UNITED STATES PATENT AND TRADEMARK OFFICE

APPLICATION NO.	FILING DATE	FIRST NAMED INVENTOR	ATTORNEY DOCKET NO.	CONFIRMATION NO.
10/790,217	03/02/2004	Akira Yoneoka	P21-163407M/NY	9855
21254	7590	12/15/2005		
MCGINN INTELLECTUAL PROPERTY LAW GROUP, PLLC 8321 OLD COURTHOUSE ROAD SUITE 200 VIENNA, VA 22182-3817			EXAMINER MITCHELL, KATHERINE W	
			ART UNIT	PAPER NUMBER
			3677

Office Action Summary

DETAILED ACTION

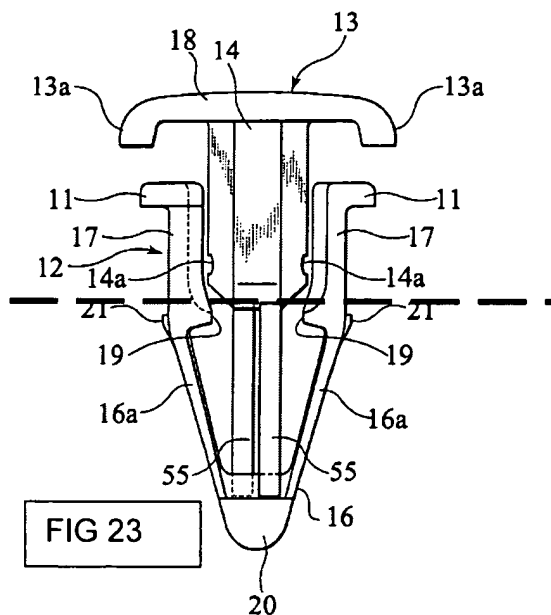
11. As best understood by examiner, claims 1- 8 and 12-14, and 21 are rejected under 35 U.S.C. 102(b) as being anticipated by Arisaka USP 6511273.

Re claim 1: Arisaka teaches a jointing member comprising a grommet 12 and pin 13. The grommet has a flange and leg portions, capable of being opened, and there is an insertion hole in the center of the flange to an inner portion of the leg. There is an engagement portion (19) on the leg portion. The pin includes a head and shaft, said shaft insertable in the insertion hole of the grommet, the shaft has an engagement surface (unnumbered @ 45 degree sloped bottoms just below each of the "14a's" in Fig 23 below) and a lock surface (14a) each engageable with the engagement portion. The distance from the grommet flange to the grommet leg portion tip is greater than a distance from the pin head to the pin tip.

Re claim 2; The pin is axially movable when the grommet engagement portion engages the pin engagement surface.

Re claims 3,4: The grommet engagement portion engages the pin lock surface when the pin moves along the lock surface while maintaining the leg portion in an open state.

Re claims 5,6,7,8: The tip end of the shaft portion is buried in the grommet insertion hole when the grommet engagement portion engages the pin engagement surface.

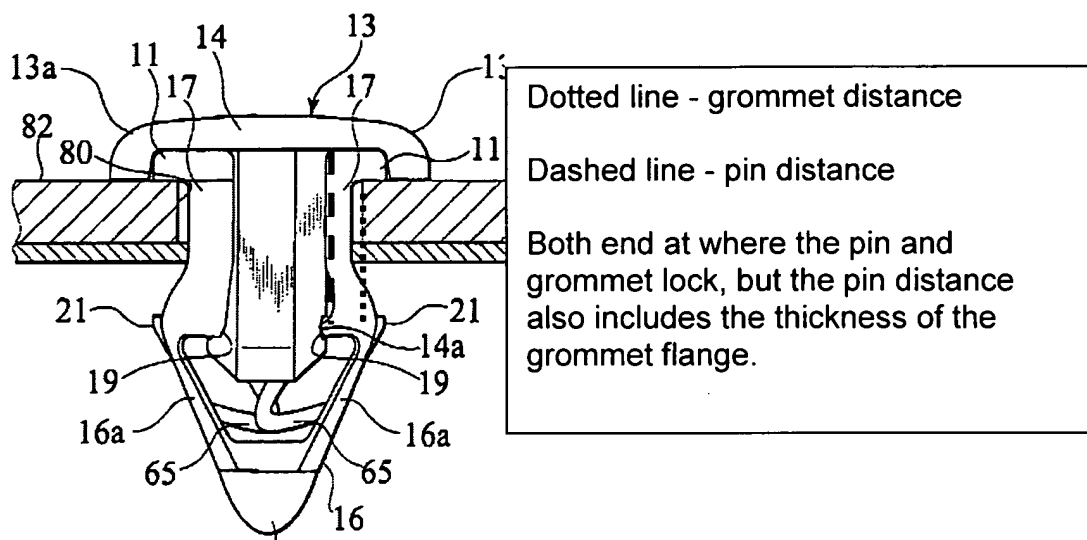
Re claim 12; The engagement portion 19 comprises a protruding portion extending from the leg inner surface.

Re claim 13: There are a plurality of slits (best seen Fig 22 -- between leg portions 16a and 16a, and also having hinges 55 in the slits) in the grommet dividing the leg into a plurality of leg pieces.

Re claim 14: Anything below the dashed line by examiner is considered where an expanded tip end side of the leg begins. Note that Fig 29 shows how this section expands when inserted. The engagement portion is formed on the inner surface of this tip end side.

Re claim 21: The distance from the grommet flange to the grommet engagement portion is smaller than the distance from the pinhead to the pin lock surface (best seen

in Fig 29:

FIG. 1

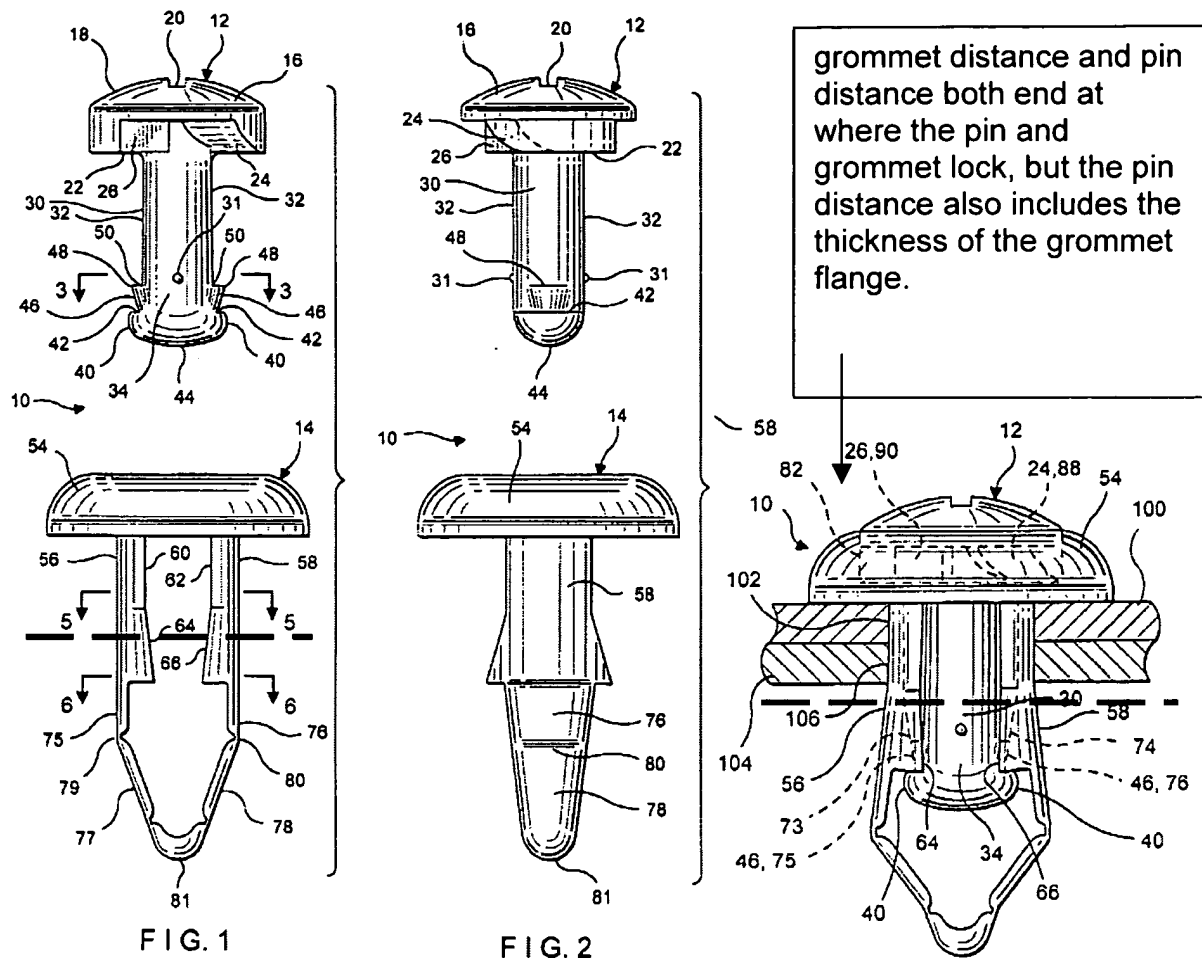
Re claim 12; The engagement portion comprises a protruding portion extending from the leg inner surface - see Fig 1 and 9.

Re claim 13: There are a plurality of slits (best seen Fig 1 -- between leg portions 77,78, in the grommet dividing the leg into a plurality of leg pieces.

Re claim 14: Anything below the dashed line by examiner is considered where an expanded tip end side of the leg begins. Note that Fig 9 shows how this section expands when inserted. The engagement portion is formed on the inner surface of this tip end side.

Re claim 21: The distance from the grommet flange to the grommet engagement portion is smaller than the distance from the pinhead to the pin lock surface (best seen in Fig 9)
